Coastal Access – Amble to Bamburgh length ABB4

Representations with Natural England's comments

July 2020

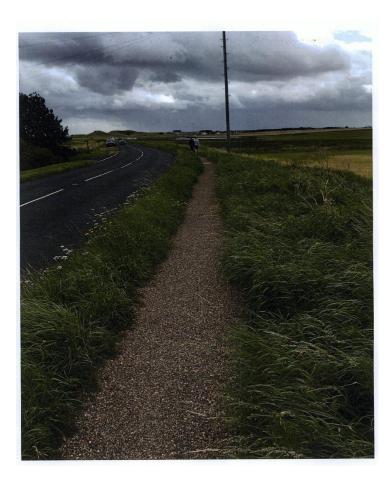
Since your survey of the coastal path between Beadnell and Bamburgh, in fact only two or three months ago a substantial quality footpath has been constructed along the side of the B 1340 road between Seahouses and Bamburgh. It joins the northernmost point of the existing pavement into Seahouses and the southernmost point of the pavement into Bamburgh. It is well constructed, smooth and level and is suitable for persons walking two abreast (ideal if you are walking with a child and wish to hold their hand) and for wheelchairs and prams. There are views of the sea and the Farne Islands. Inland the views are dramatic with Bamburgh Castle ahead of you (or behind) and Cheviot and Hedgehope visible on the distant skyline.

In the light of this new game changer footpath along the road I wish to make representations regarding your proposed path along the dunes, that this path if better for the following reasons and that the path along the route you propose is unnecessary.

4.2.9 The need for steps. Steps would quickly fill up with the wind-blown sand and would become ineffective or require frequent excavation. Wind-blown sand and voracious growth of the Marram Grass make maintenance of a path through the dunes challenging or not possible.

4.2.18 No cost required the path is already in existence.

4.219 Minimal signage required as the path is so obvious and self-evident. No surface upgrade or access furniture required. Footpath of a very high standard already.

The proposed route is safe and convenient as it avoids the need to cross the B1340 Bamburgh to Seahouses road in two locations. It also reduces the number of interruptions to the user. The B1340 can get quite busy during the peak summer holiday months, which would likely coincide with when the proposed route would carry the most users.

Evidence from numerous site visits tells us that the proposed route is the one that walkers are currently using. The proposed route maintains views of the sea and local points of interest like the Farne Islands and Bamburgh Castle.
